RECEIPT DATE: 7/28/17 **ONSITE SEWAGE DISPOSAL SYSTEM** P 561473
 APPROVAL DATE: 8/24/17 **PERMIT: CONSTRUCTION** A _____
 PROPERTY ADDRESS: 5054 GAITHER'S CHANCE DRIVE, CLARKSVILLE, MD 21029
 SUBDIVISION: GATHER'S CHANCE LOT: 9 TAX ID: 05-598955
 CONTRACTOR: Matfield's Equipment EMAIL: _____
 CONTRACTOR ADDRESS: P.O. Box 519 / Annapolis Junction, MD 20701 PHONE: 410-984-0047
 PROPERTY OWNER: MB GAITHERS CHANCE LLC EMAIL: MQUINT@MITCHELLBEST.COM
 OWNER ADDRESS: 1686 E GUDE DR., ROCKVILLE, MD 20850 PHONE: 443-691-4201

SITE PLAN FOR SEPTIC SYSTEM INSTALLATION

GAITHER'S CHANCE
 LOT 9 (5054 Gaithers Chance Drive)
 PLAT No. 23701

Marshall Property Subdivision

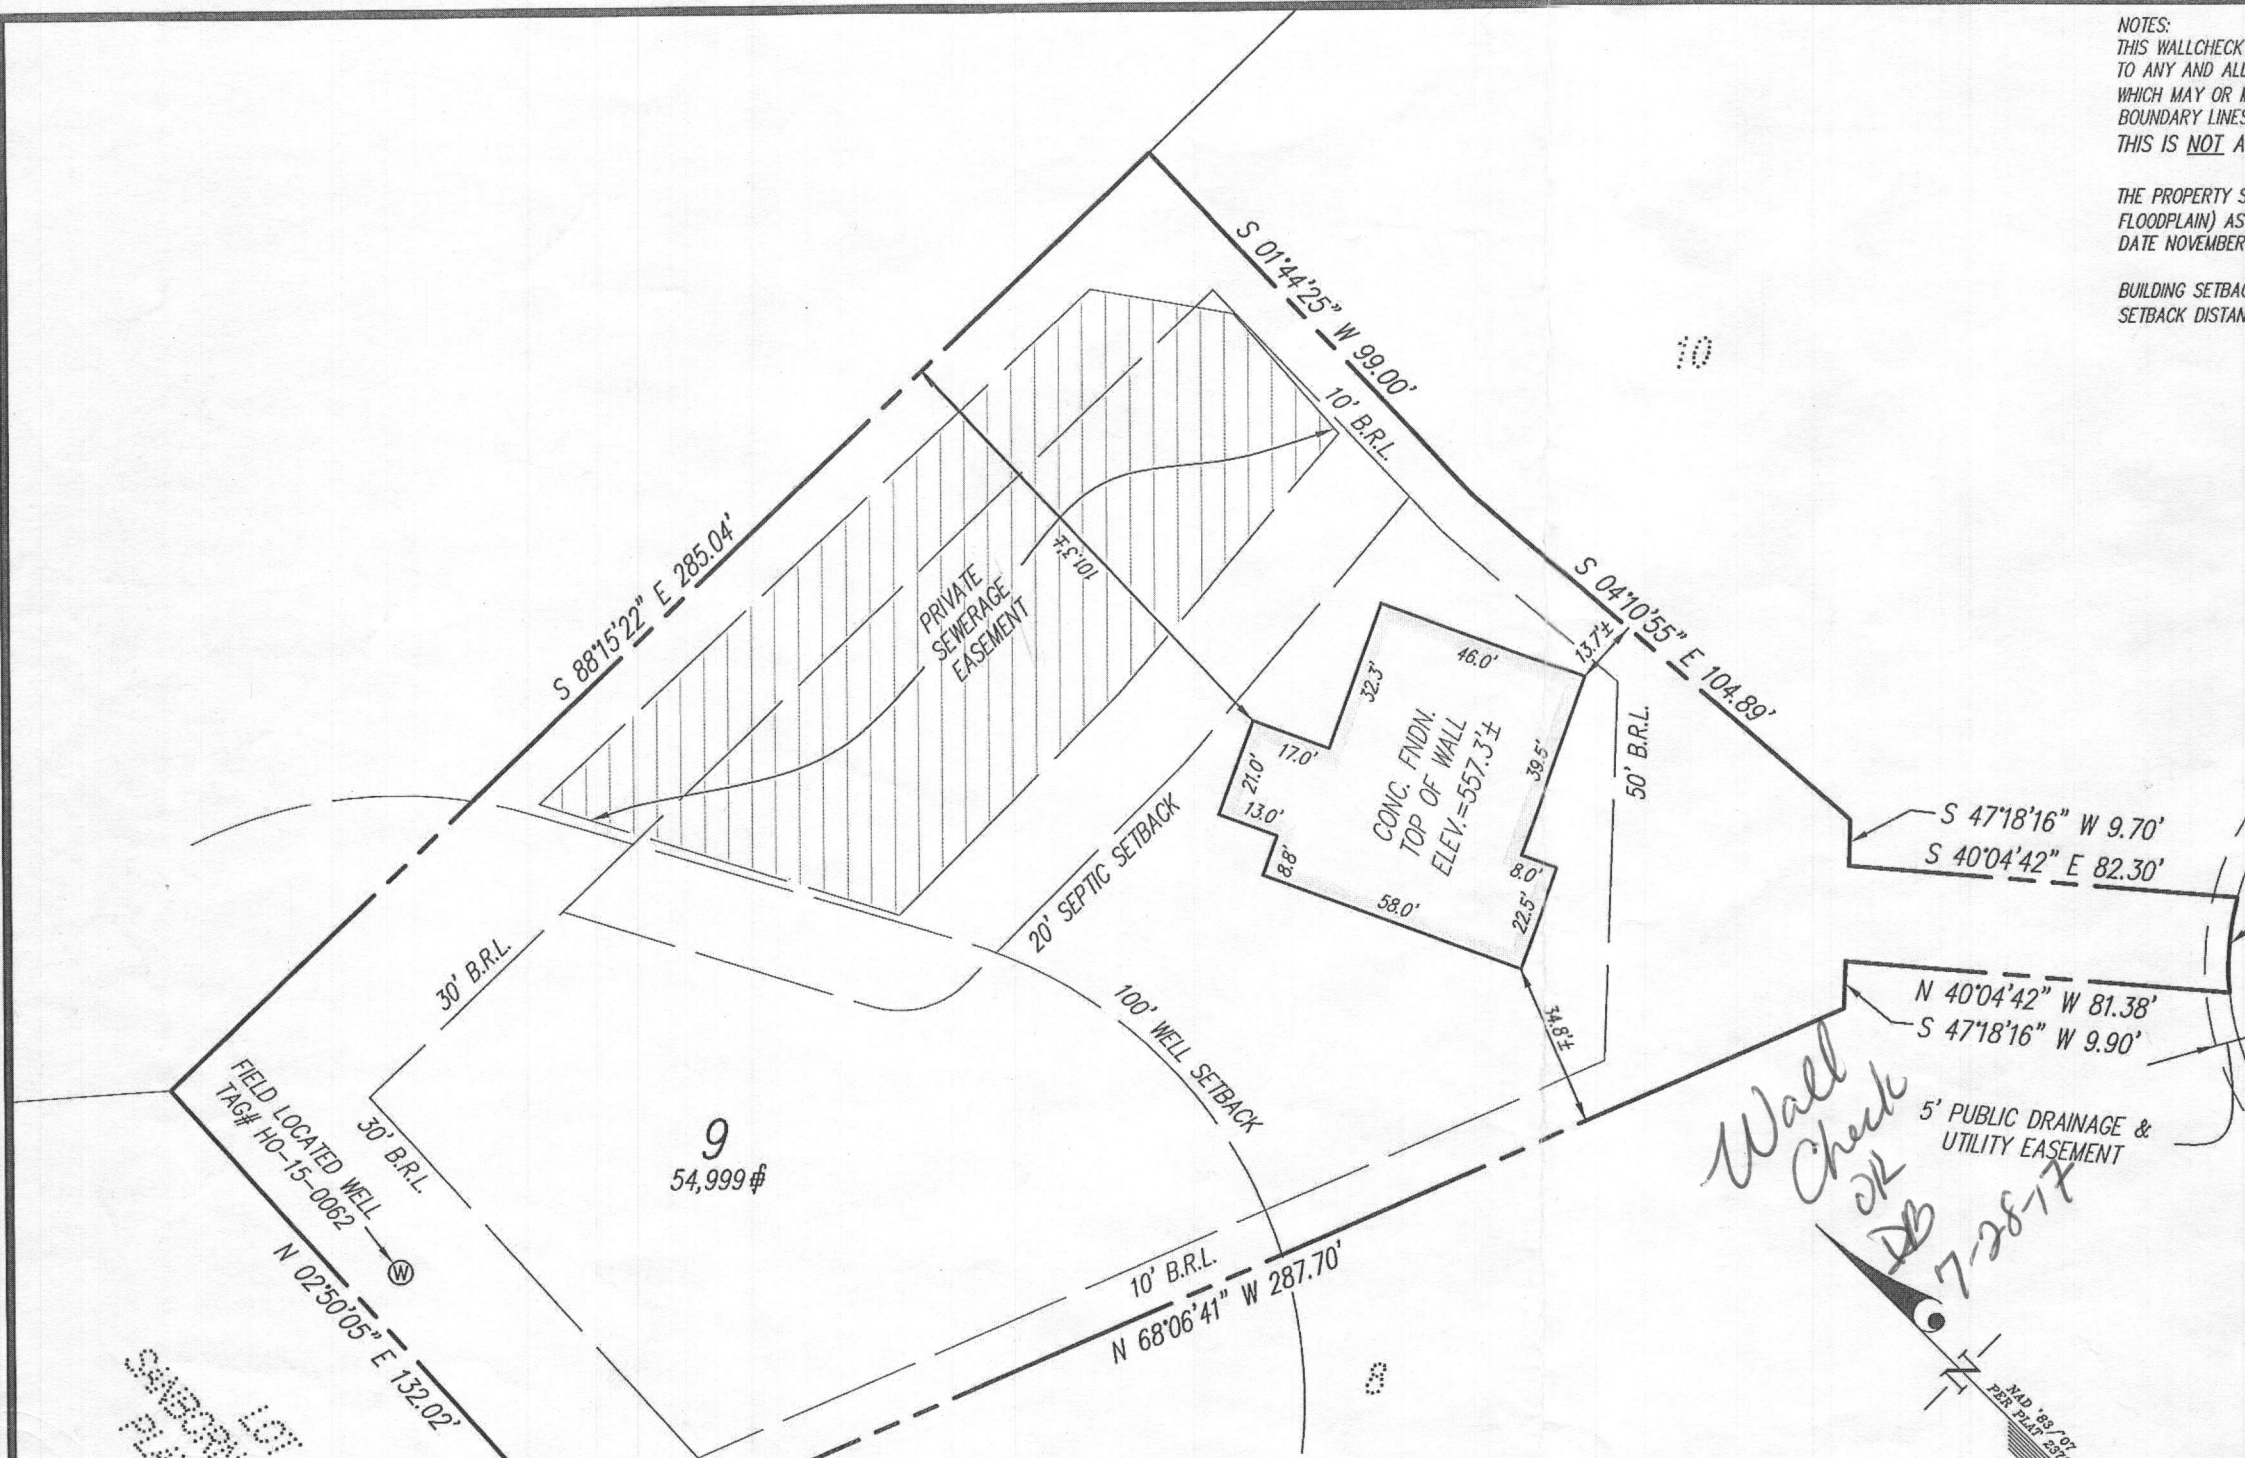
Design Septic System

Distribution Trenches

as shallow as possible

AND still have at least

3 drain fields in SDA.

req per Bert

Sheet Number

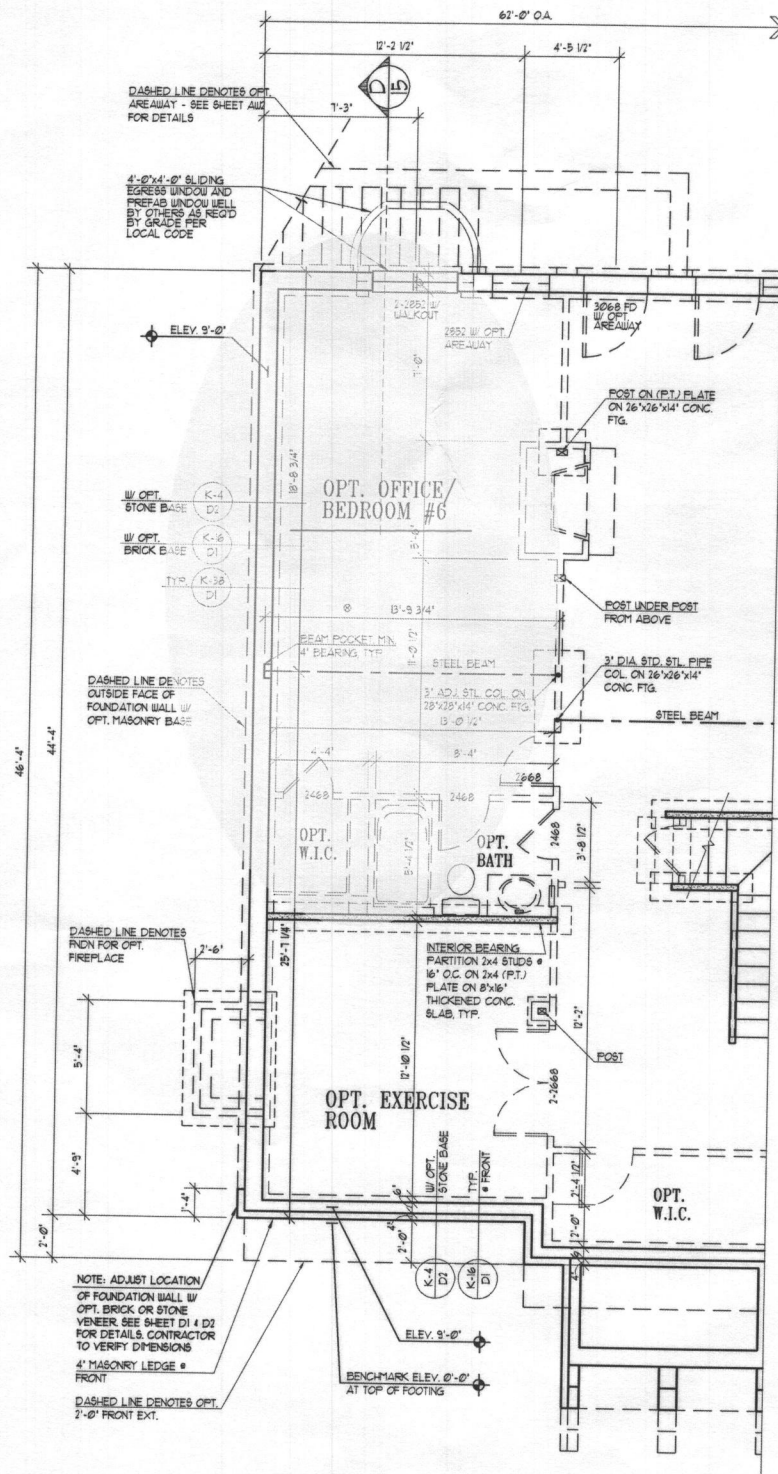
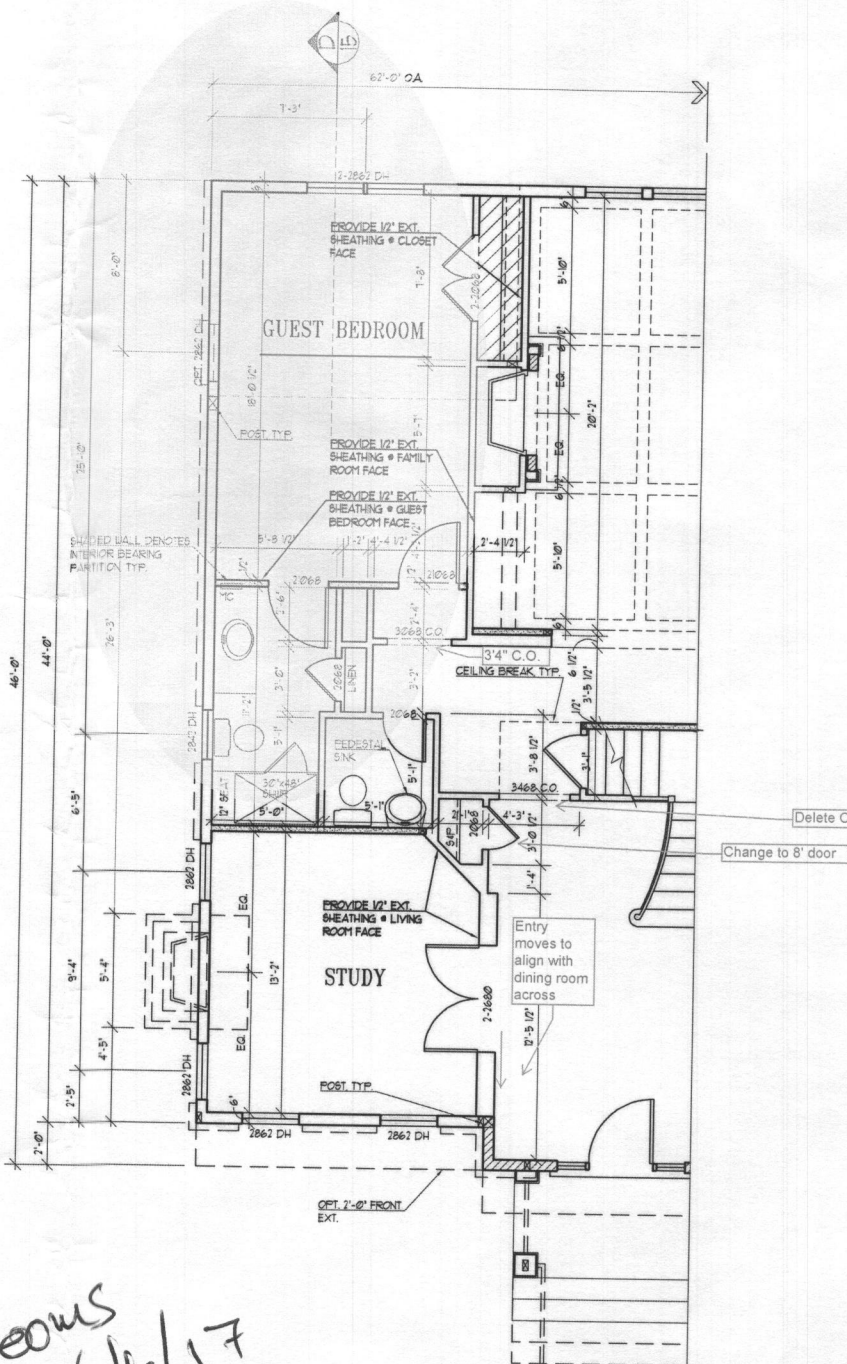
*2 Bedrooms
OK' RB 6/11/17*
